ADDENDUM No. 9 - March 7, 2019

South High Community School 170 Apricot Street, Worcester, MA 01603

SHEET REF. NO. DRAWING NAME: Partial First Floor Plan -Section B2 DATE: DRAWING NUMBER: 03/07/19 SCALE: 1/8" = 1'-0" A-029 REFERENCE:

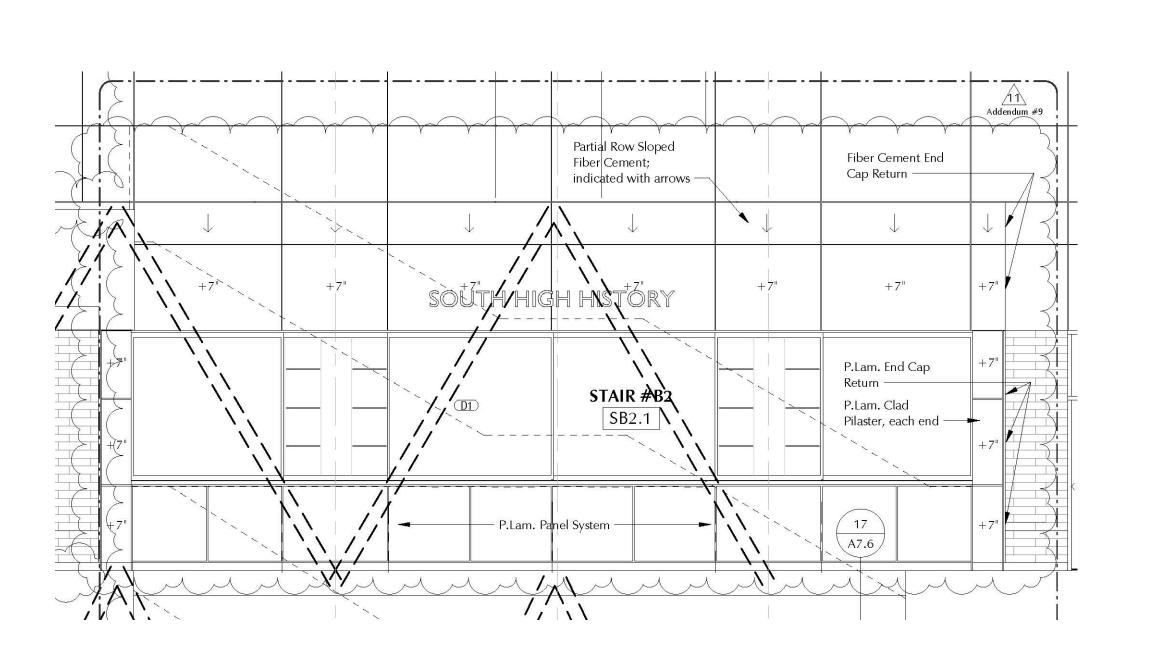
- A. At Closet B102.1, add section cut mark 11/A9.5.
- B. Along column line 37, in Vestibule B130.1, delete references 14/A8.26 and 15/A8.26.
- C. At Floor Plan drawing 3/A3.6, revise floor plan for Display Cases D1 and D2 and its key references, refer to ADD-9 A-029
- D. At floor plan 3, in room B101 insert millwork tag "MW1"

DRAWING NAME: Lobby Partial NW Interior Elevation

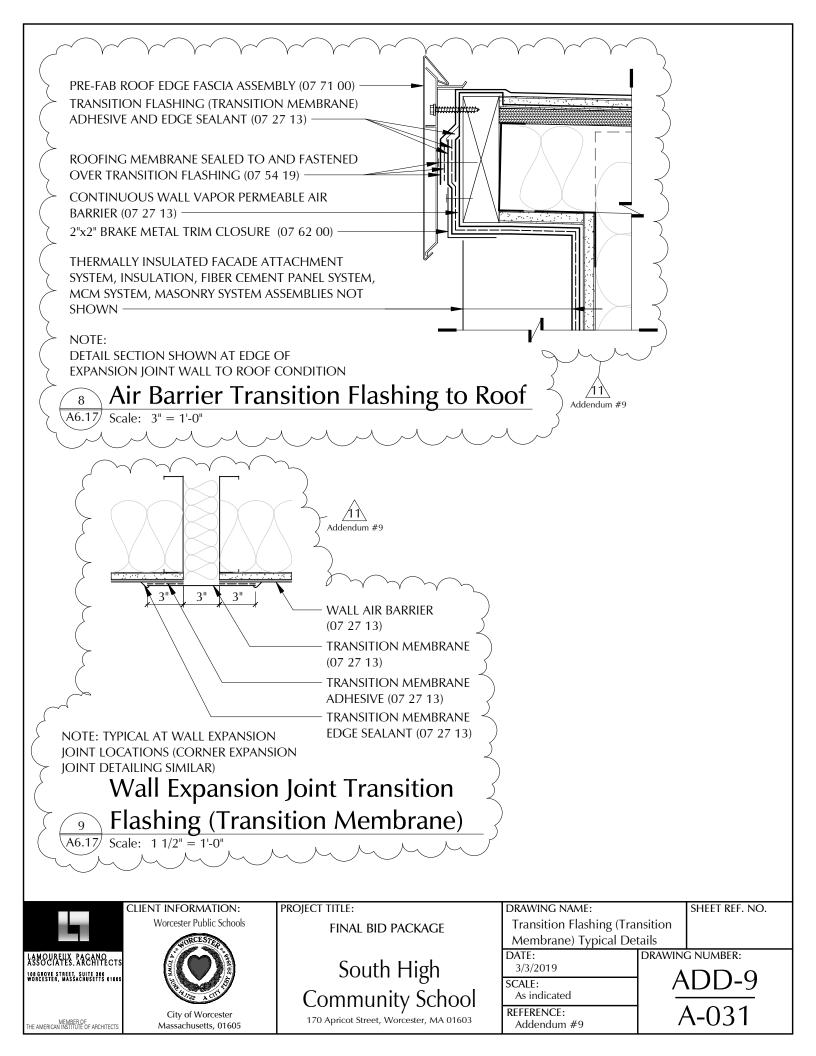
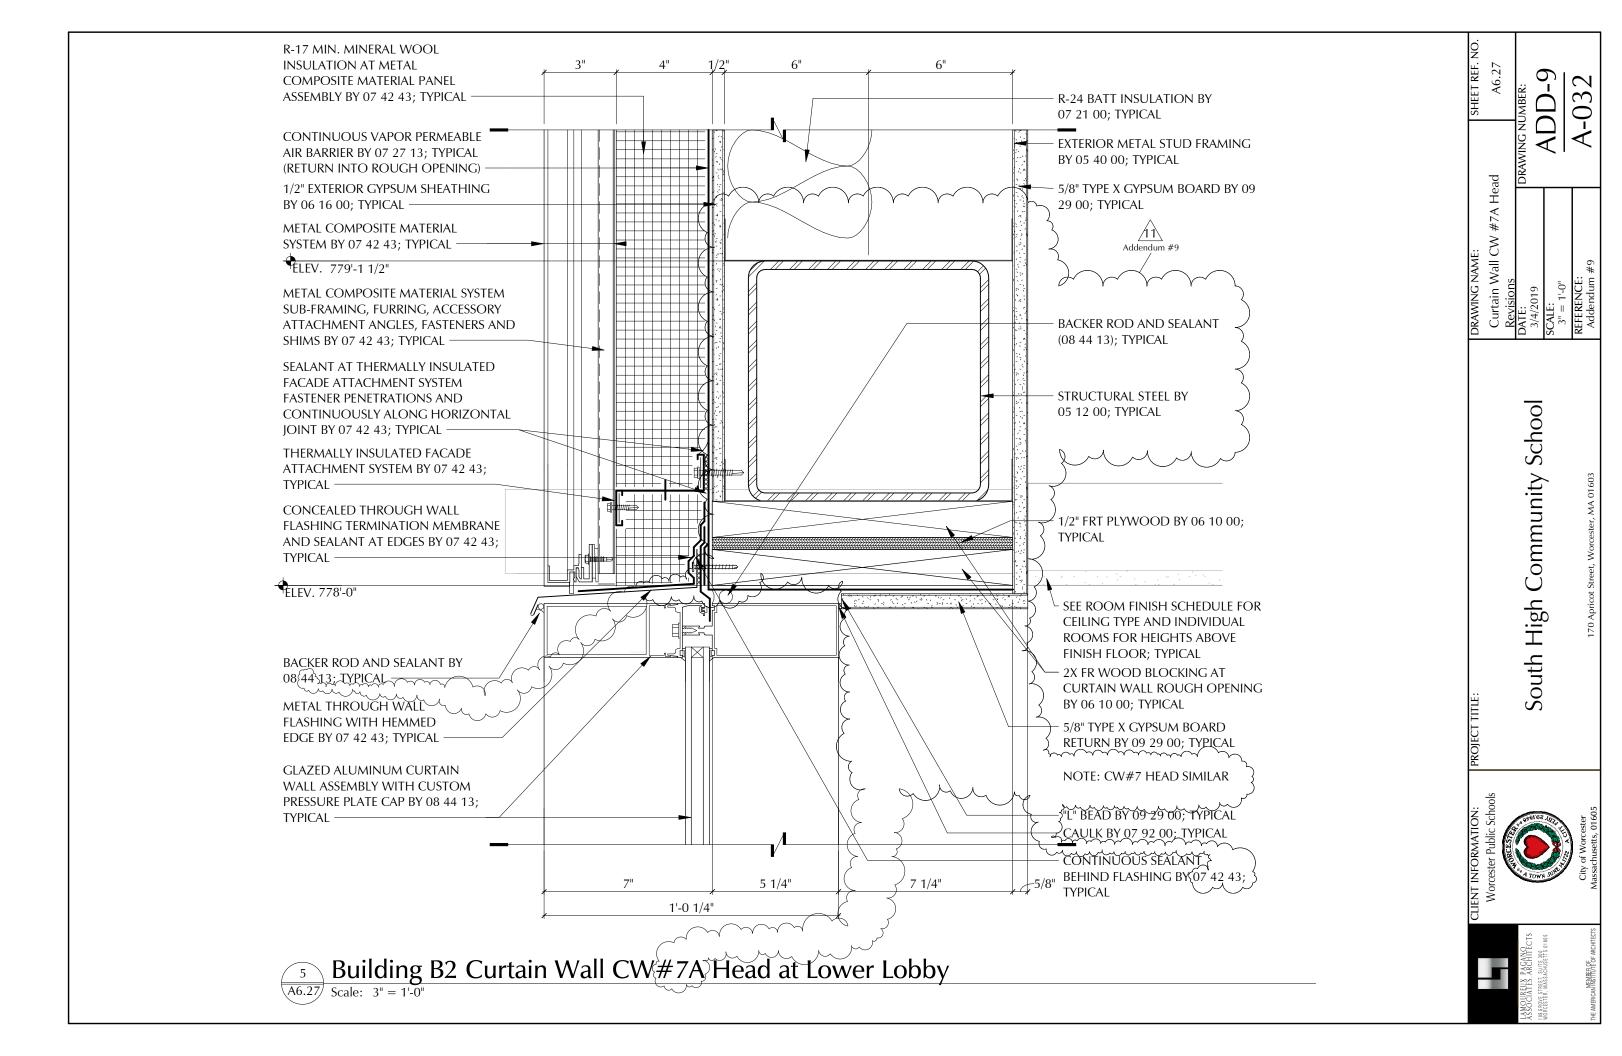
- A. Clarification: Terrazzo tile base is continuous below thin brick and fiber cement panel wall material.
- B. Revise elevation 5/A8.10, refer to sketch ADD9 A-030.

Ceramic Tile At Kitchen B184 A3.4

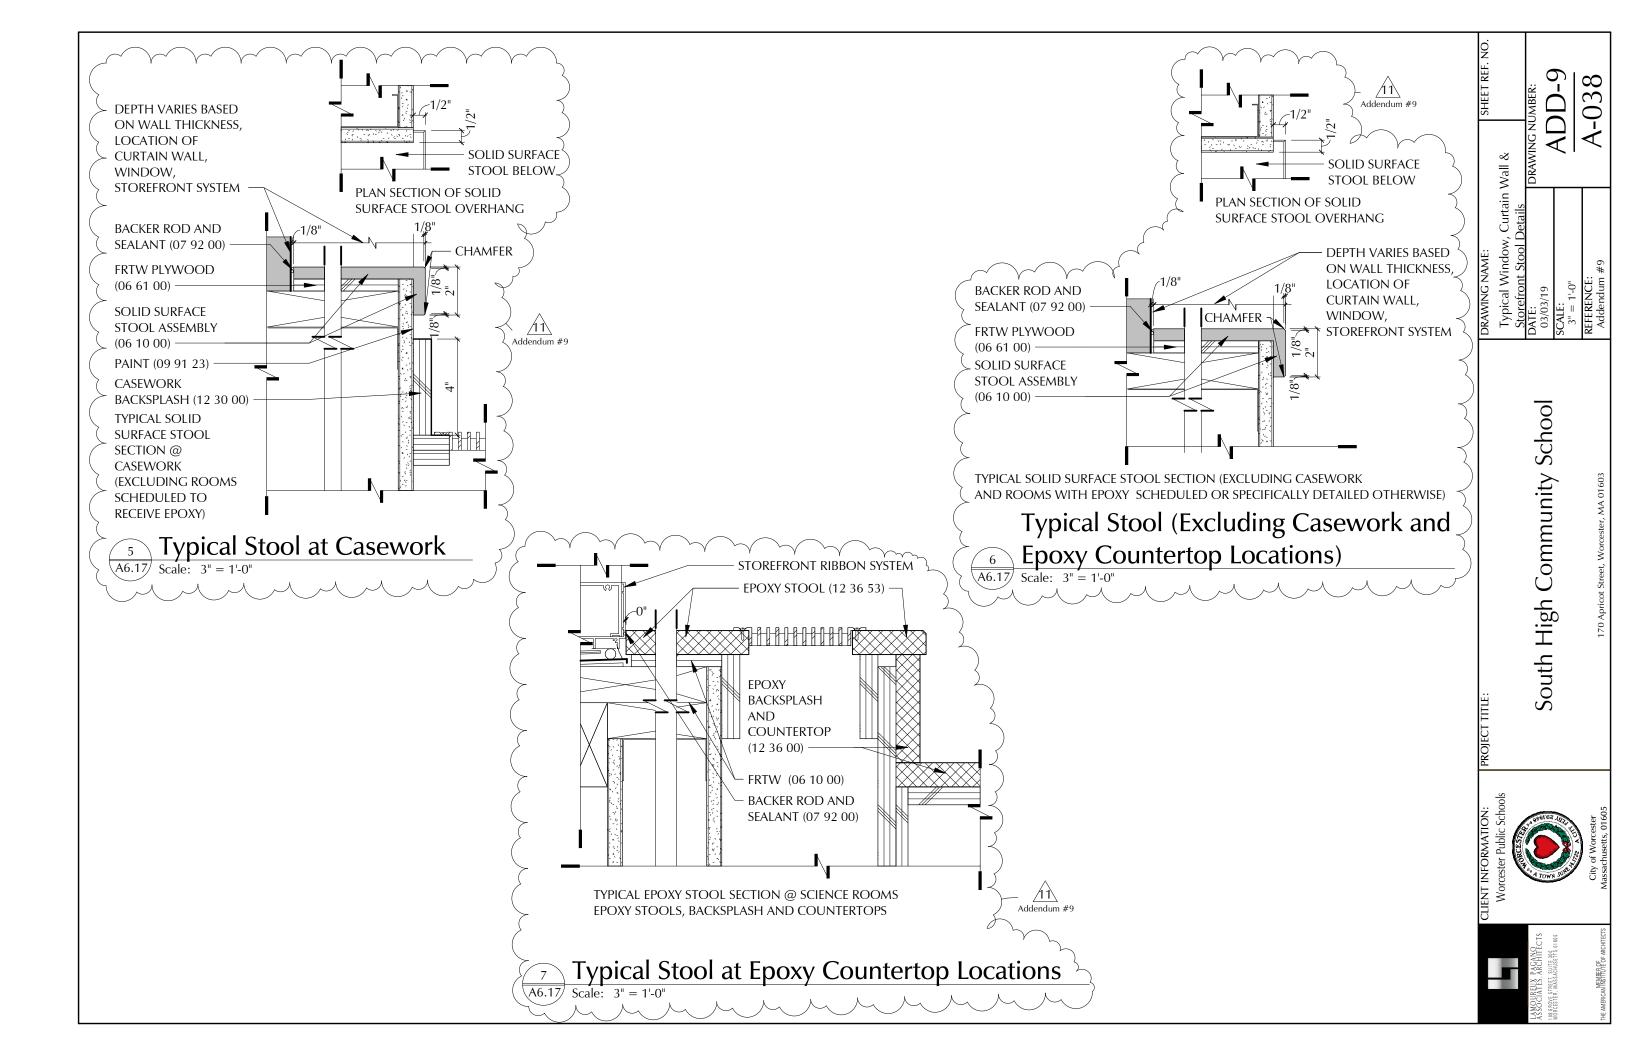
- A. For Kitchen B184, update wall finish to "FRP/CERAMIC ACCENT TILE TO CEILING"
- B. On FINISH KEYNOTES LEGEND, add General Note: "5. Where base finish calls for "4"/6" Vinyl", provide 6" vinyl base at under-window casework vertical pencil grilles. All other walls to receive 4" vinyl base."
- C. For Toilet B105, change the wall finish from "GWB PAINT" to "TILE/PAINT"
- D. For Lower Auditorium B175, add note "Refer to Elevations A8.12"

SHEET REF. NO. E9.09 DRAWING NUMBER:
ADD-9 E-098 REFERENCE: FPB - Addendum #9 DRAWING NAME: Panel HSP13 DATE: 03/07/19 SCALE:

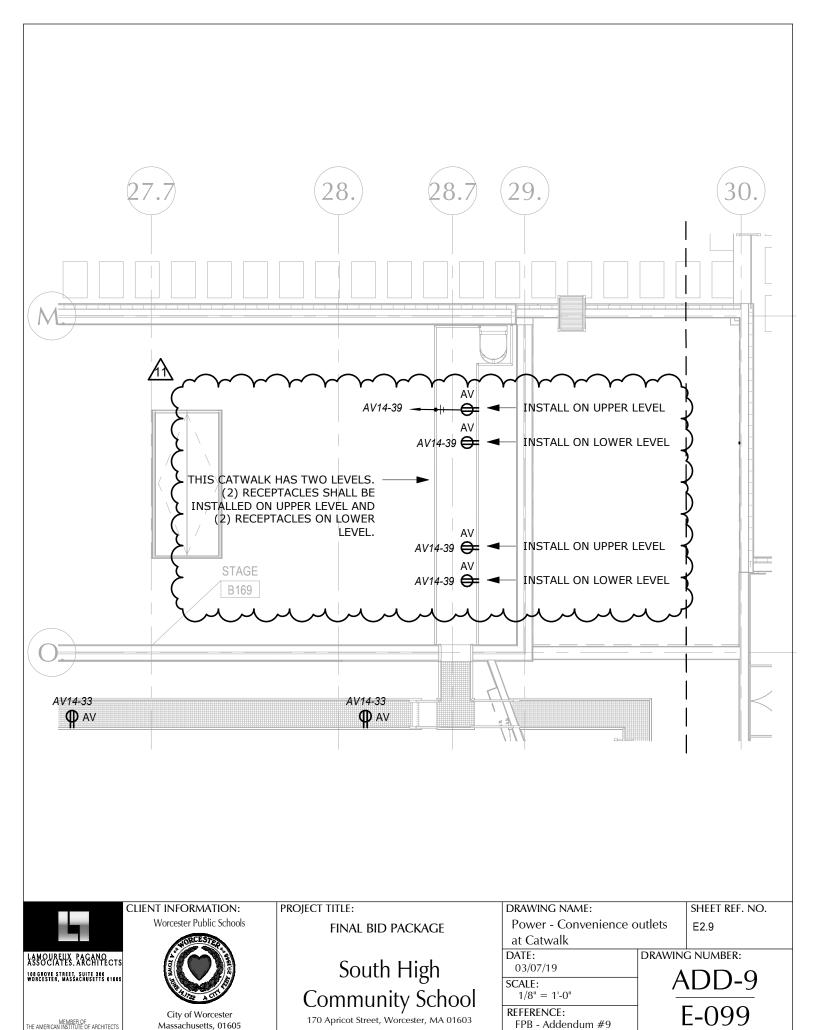
- A. Refer to Sketch ADD-9/E-098
- B. Refer to Sketch ADD-9/E-101
